Subject: Agenda Item for the May 11, 2020 Plan Commission Meeting

Request by Edward and Patricia Bierer of Stellar Services for approval of a building addition at 301 Business Park Circle.

Approving a site plan for a building addition at Stellar Services, 301 Business Park Circle, Stoughton, WI.

I have completed a final review of the proposed building addition/site plan for Stellar Services, LLC., 301 Business Park Circle. This item is planned to be on the Plan Commission and Business Park North agendas for May 11, 2020 of which you will receive notice. This project is also subject to the Business Park North Covenants as outlined below. As noted, additional information may be required to be provided or shown on the plan.

Landscape Plan

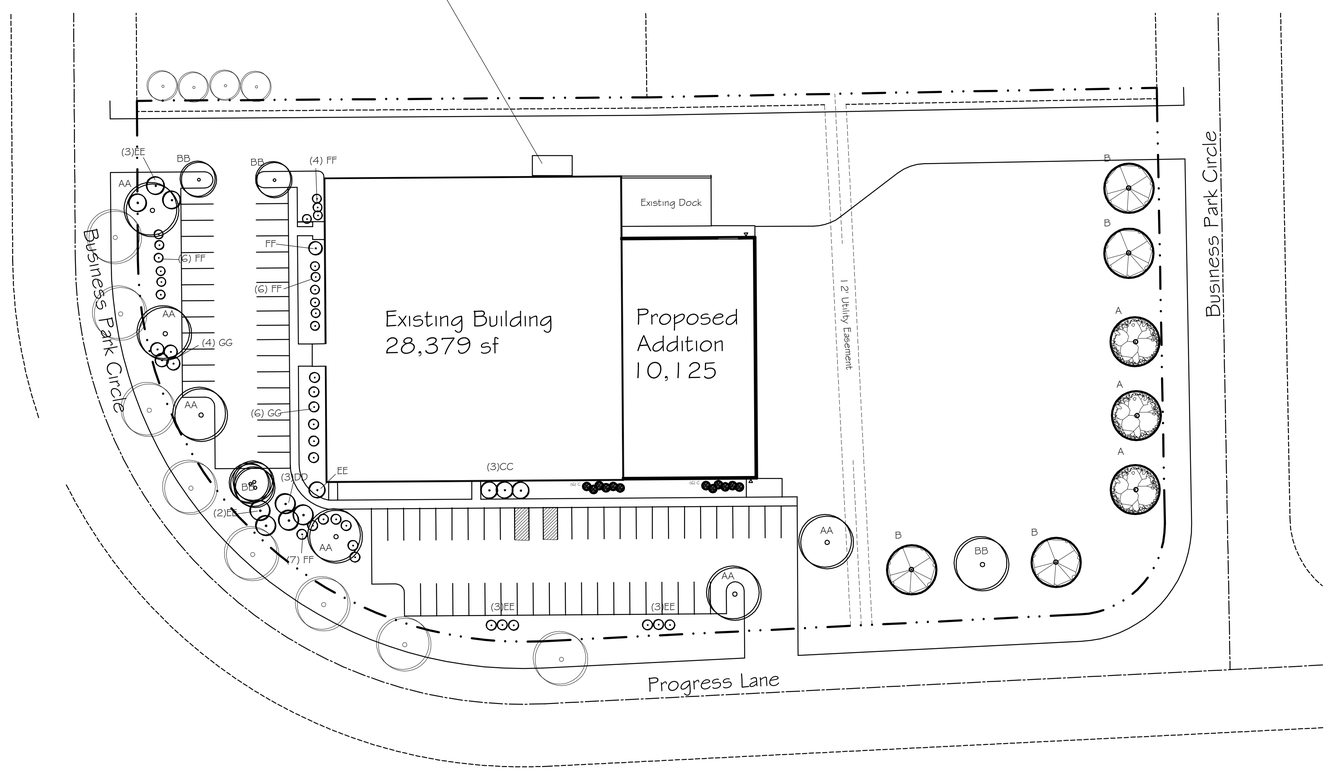
12. A landscaping plan for the building addition is required as follows:
    - Building foundations: 40 points of landscaping are required per 100 feet of foundation perimeter. 435 feet of foundation requires 174 points of landscaping which is required to be planted within 10 feet of the building foundations. Climax and tall trees cannot be used to meet this requirement.
    - Developed Lots: 10 points of landscaping are required per 1,000 square feet of building footprint. 10,125 square feet of building requires 102 landscaping points.

The provided landscaping plan takes into account the entire building including the addition.

Exterior Elevations

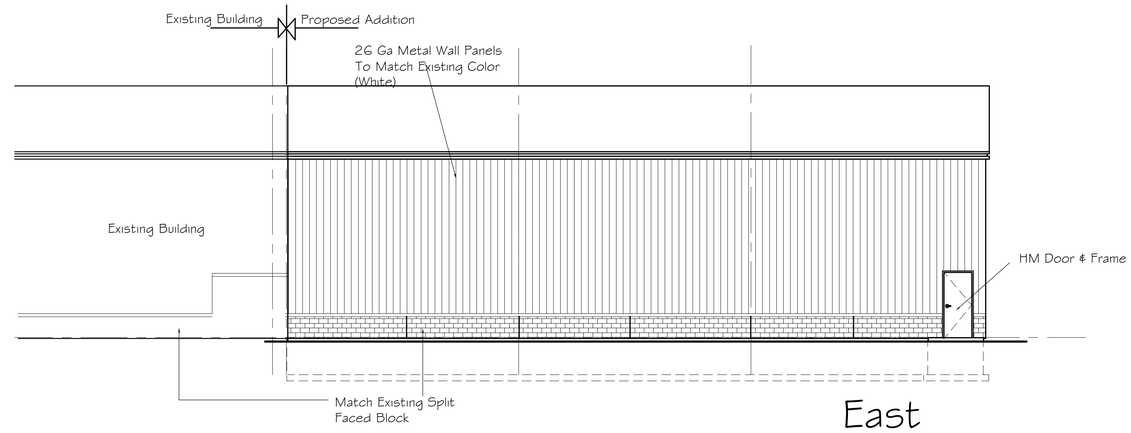
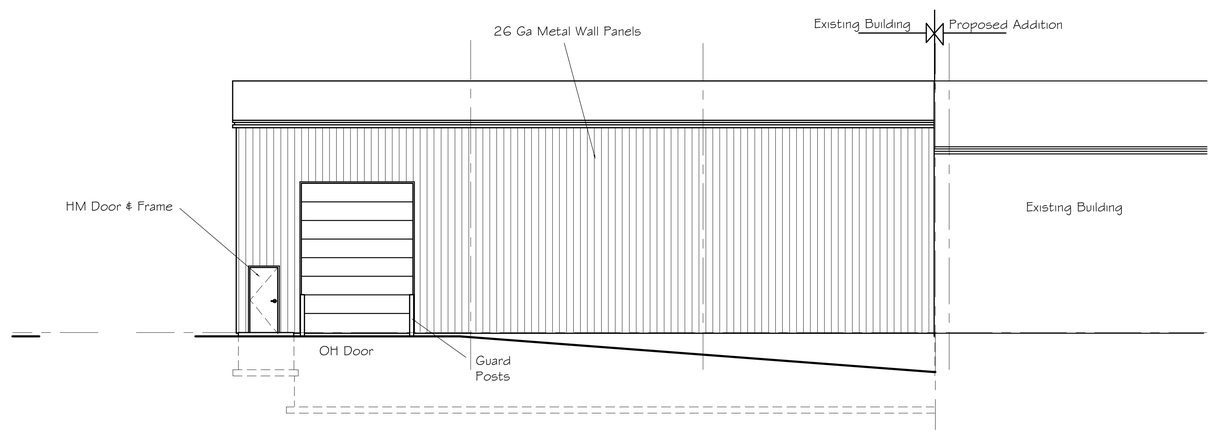
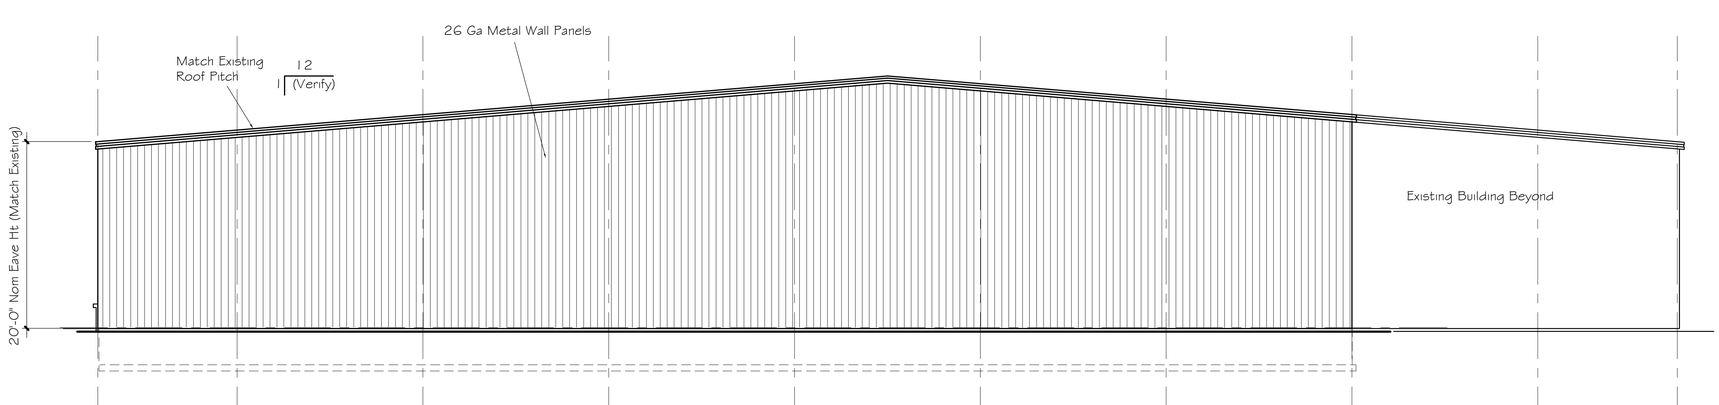
2. Development Standards
   a. The front facade and street-side facades shall include brick, stone, architectural concrete panels, architectural metal, architectural wood and/or glass. Unfaced concrete block, structural concrete, prefabricated metal siding, and the like are discouraged from such facade areas. The use of these materials shall only be in a manner approved by the Committee. Special consideration will be exercised for structures built on a corner lot. **This is a corner lot so consideration should be given in requiring all frontages to be brick.**
